**Dan McKeel's Personal Notes on the
August 28, 2012, Meeting of the
TBD-6000 Work Group of the ABRWH**

Daniel W. McKeel, Jr.
GSI SEC-00105 Co-Petitioner

ABRWH
Work Group on TBD-6000
9:00 a.m. EDT

Dan McKeel napkin drawing 4 corner GSI Betatron shot MCW Ur

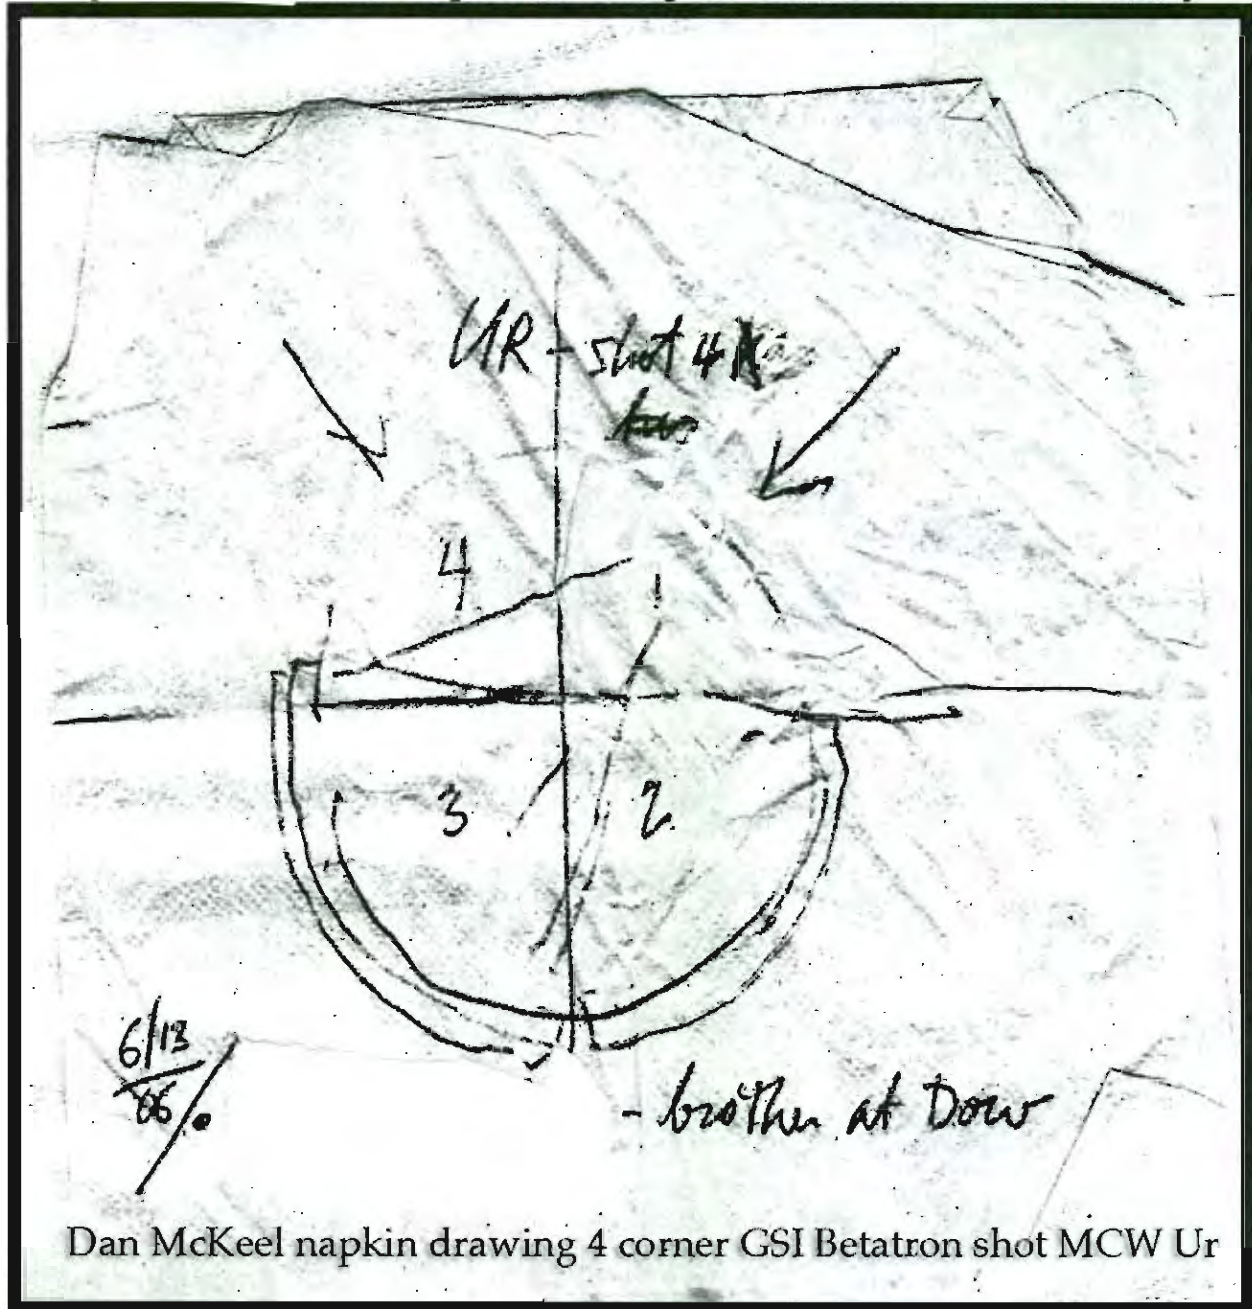
(1) See McKeel napkin drawing of Betatron uranium corner shots made at GSI, **page 26**; (2) GSI radiography supervisor also confirmed there were four "corner shots" performed on MCW uranium dingots. (See **interview APPENDIX A**); (3) On **pages 27 through 30** are two of the references that John Ramspott mentioned that prove that at Mallinckrodt Uranium Division, which contracted with AEC and GSI for the Ur NDT radiography work 1953-June 1966, the main purpose was to define the crust/underlying pure uranium metal interface, just as McKeel and Ramspott have claimed, on multiple occasions, and provided this same proof, only to be ignored and not taken seriously as was very evident at this meeting. *Bill Thurber and*

Bob Anigstein and DCAS (Mr. Allen, Dr. Neton) have just not gotten their facts correct.

Fuel Tests:

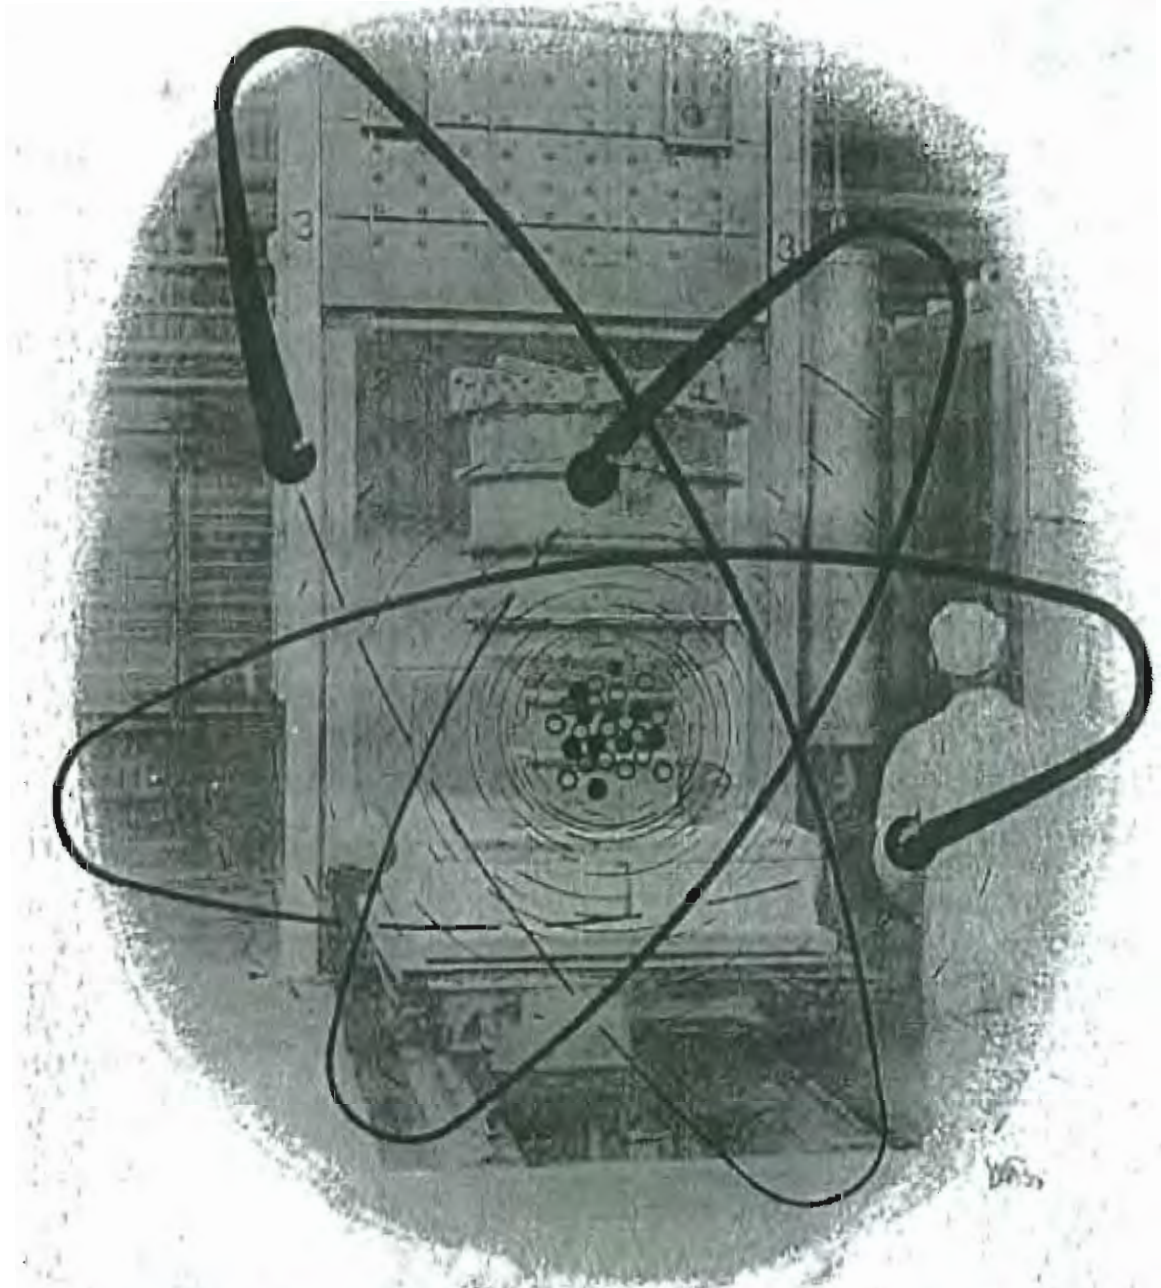
Uranium, like most metals, shrinks on solidifying and blowholes and pipes are formed in the ingots. The amount of metal to be removed by cropping in order to produce sound material for rolling is determined by the use of high-energy X-rays. This test has supplemented other work in aiding the development of improved casting techniques. Uranium alloys may be cast in rounds or flats so that very little if any machining is required for use. Such bars may be tested by ultrasonic techniques for soundness.

Please note the underlined passage: "*The amount of metal to be removed by cropping in order to produce sound material for rolling is determined by the use of high energy X-rays.*"
